# Section 75W Modification Application Environmental Assessment Report

## Block 3B/3C and 10 Central Park

Modification to Student Accommodation (MP 11\_0090)

December 2012 ■ 11316

**Figure 1** – Reduced building floor plates by 1,000mm (identified by the red outline)

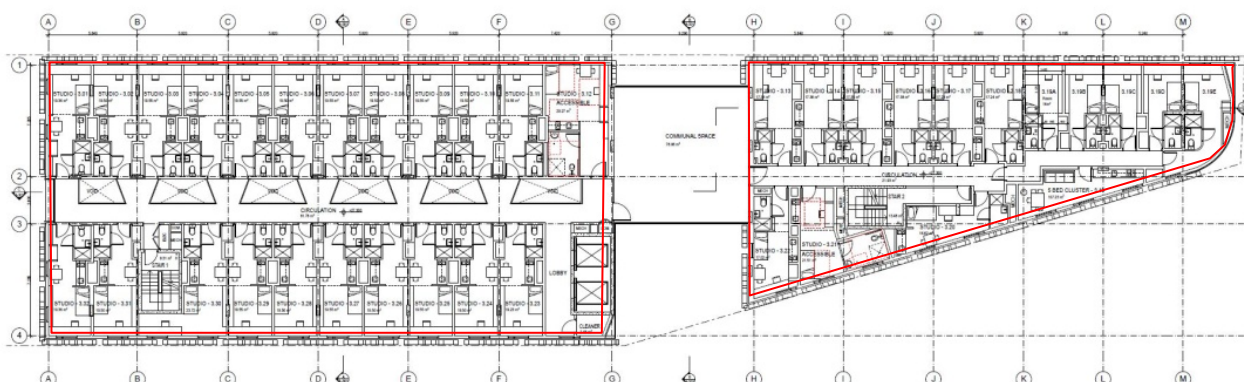
The proposal includes an overall reduction in width from the approved building from of Block 3B/3C by 500mm on the eastern and western boundary, as such a 1000mm overall reduction. The external face of the metal screens that previously protruded over the property boundary by 400mm) will now sit wholly within the site (by 100mm).

The proposed modification also involve a further reduction in overall bulk by lowering the parapet in height from the approved form by 980mm for Block 3B, 700mm for Block 3C and 420mm for Block 10. This allows for a floor to floor height of 2680mm to be achieved within the bedroom and living spaces of the units.

Figure 3 – Existing and proposed facade and window openings

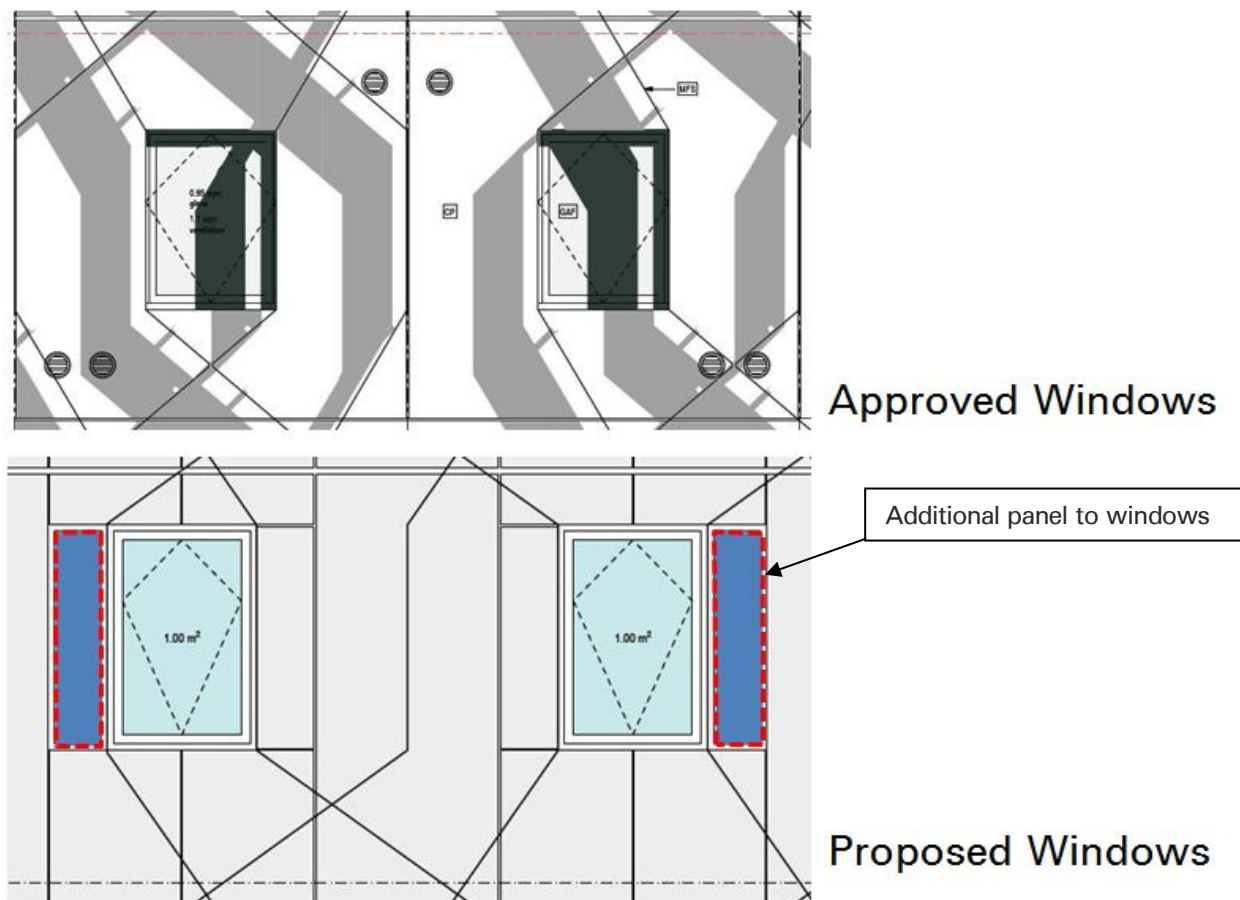
The windows to the external facade of the building are proposed to be increased in size, with an additional panel added to one side of the existing window (which proportions are slightly amended). The increase in the form of an additional panel to the facade (0.43m<sup>2</sup>)

A not to scale comparison is provided below in **Figure 3** with the additional window shown. Section and further detail of these windows and openings are provided on the Architectural Plans at **Appendix A**.

**Figure 4** – Proposed treatment of the ground floor facade to Kensington Lane

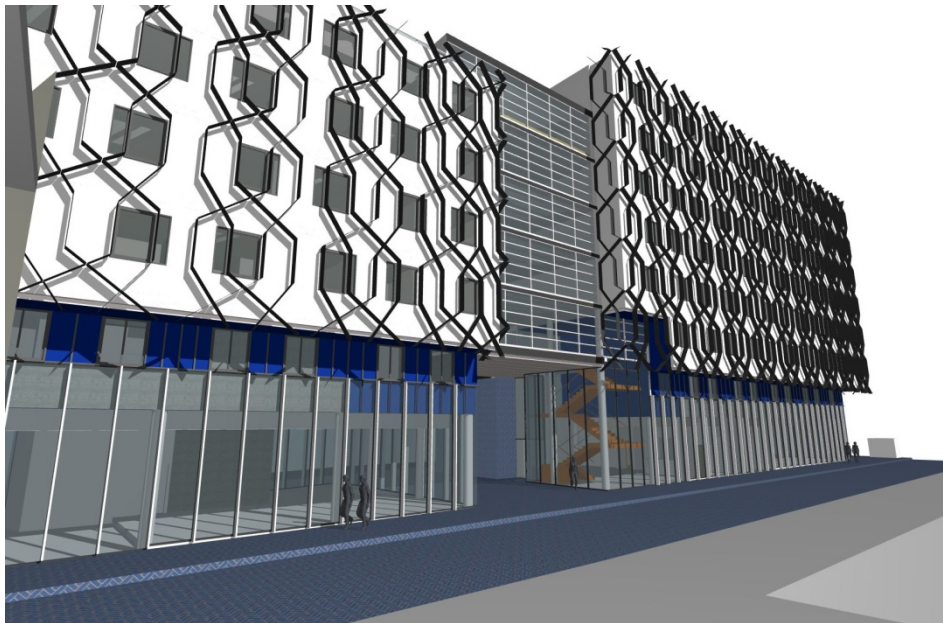
The approved development incorporated comments from City of Sydney and the Department of Planning and Infrastructure regarding the articulation of the ground floor facade to Kensington Lane, and Carlton Street, particularly to the upper portion of the ground floor glazing. The design of this part of the facade (between levels 1 and 2) and the interface has been rationalised. This design simplifies the ground level facade treatment whilst retaining the core concept of scale transition between the heritage significant terraces on Kensington Lane and the larger retail floor plan of the proposal (See **Figure 4**). Colouring is used to provide articulation to the facade. The detail of this modification can be seen on the revised views at **Appendix A**.

Figure 5 – Proposed treatment of the ground floor facade to Carlton Street

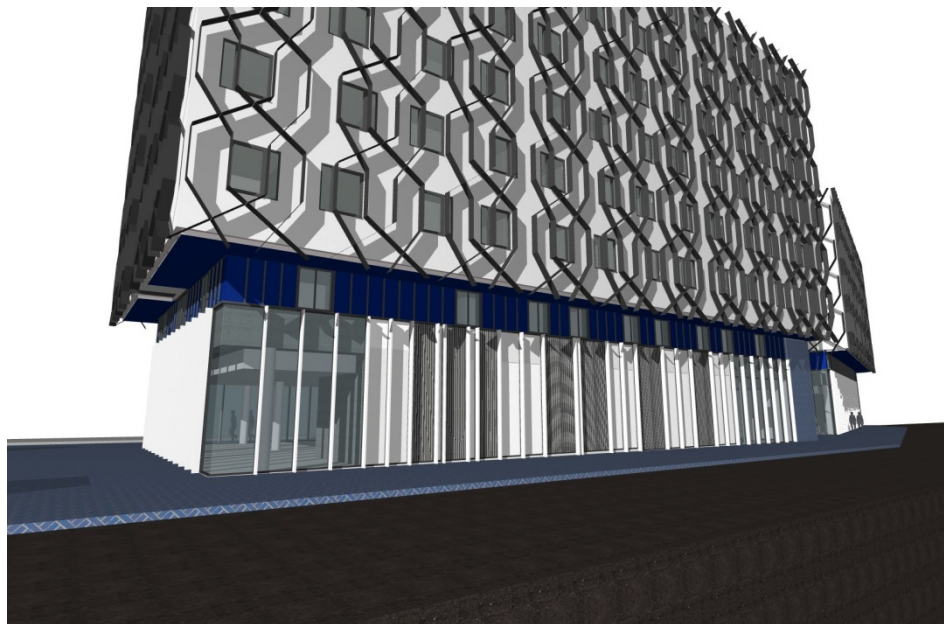
The Carlton Street ground floor elevation has been redesigned to minimise the expanses of service treatment such as metal louvers and break up the facade with translucent glazing. The vertical proportions of these are have also been expended between the ground level and spandrel. An excerpt of the architectural plans is provided below in **Figure 5** which illustrates how this will be seen from Carlton Street.

**Figure 6** – Proposed building envelope reduction (existing approval shown in red)

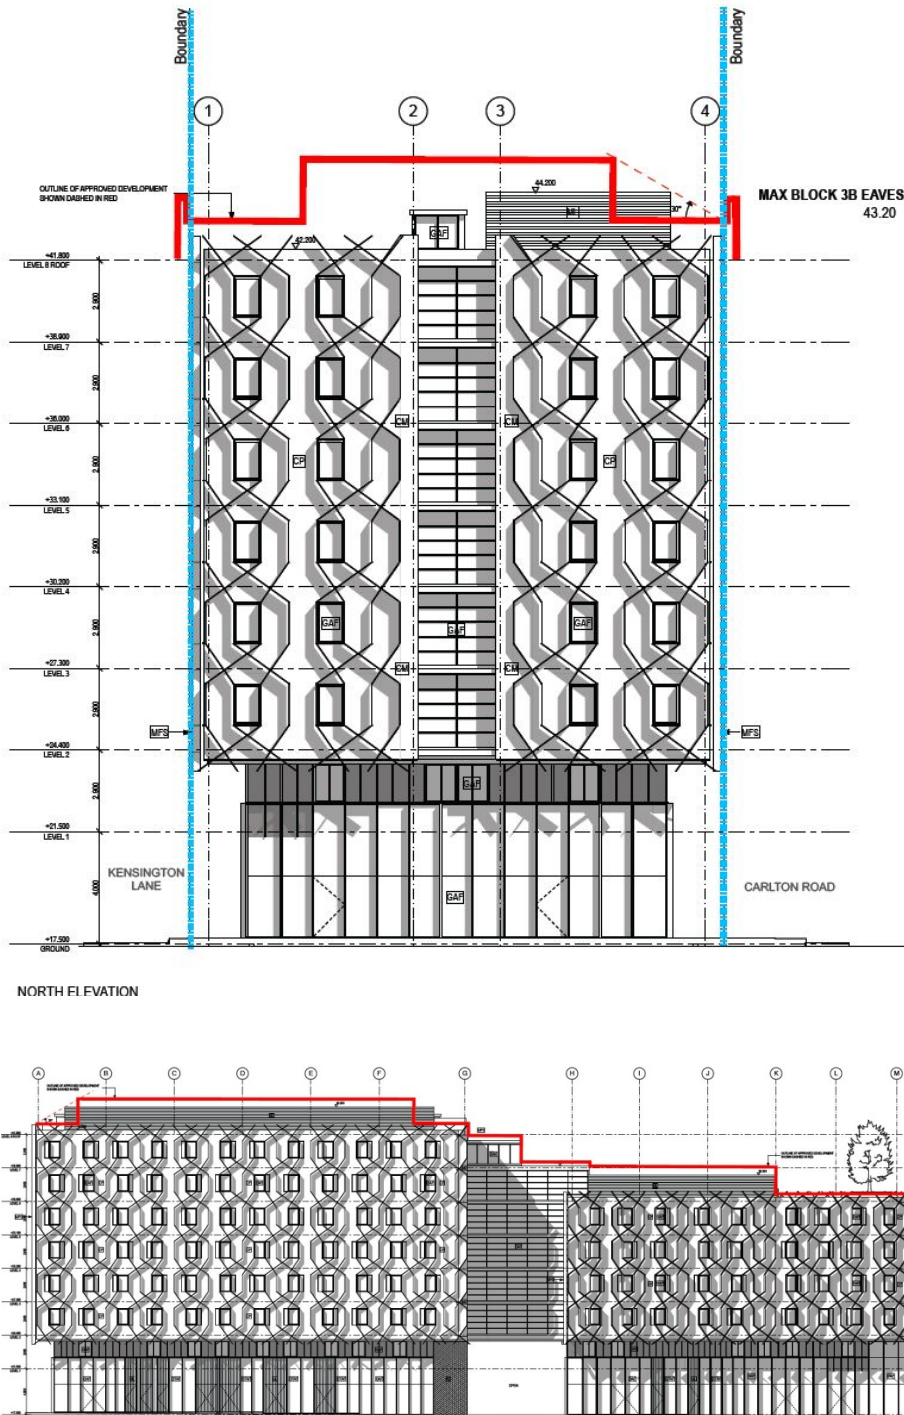
The approved building envelopes and proposed modifications are shown at Blocks 3B and 3C are shown in **Figure 6** below. The plans identify the line of the existing approved envelope, and demonstrate a reduction in the height and floor plate of the blocks.

Overall, the proposal is consistent with the approved envelope in that it reduces the bulk and mass, and no longer results in a boundary encroachment, and is therefore considered to be consistent with the Concept Plan.

Figure 7 – Setback to level 1 on Block 10 (left) and additional external area (right)

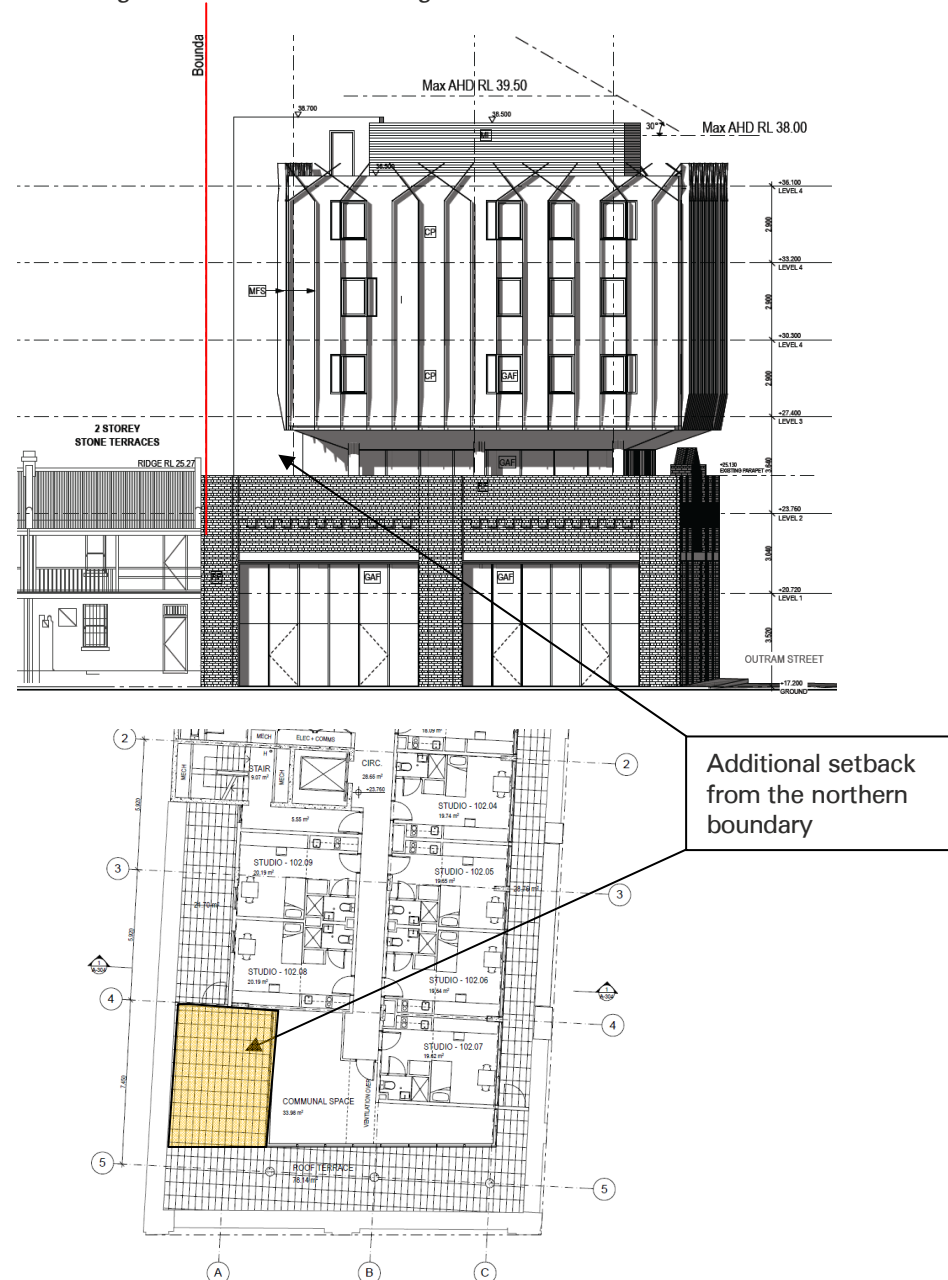
An additional communal terrace has been provided to the northern elevation of Block 10, adjacent to the internal communal area of level 1. This space has been incorporated into the proposed modification due to changes in the layout of the floor below, and a narrowing of the built form to level. As shown in **Figure 7** below, the building line of level 2 has been setback further from the northern elevation, and level 1 modified to be a double height commercial space to the

ground floor below. This results in the creation of a usable communal courtyard, afforded greater access to natural light and solar access.
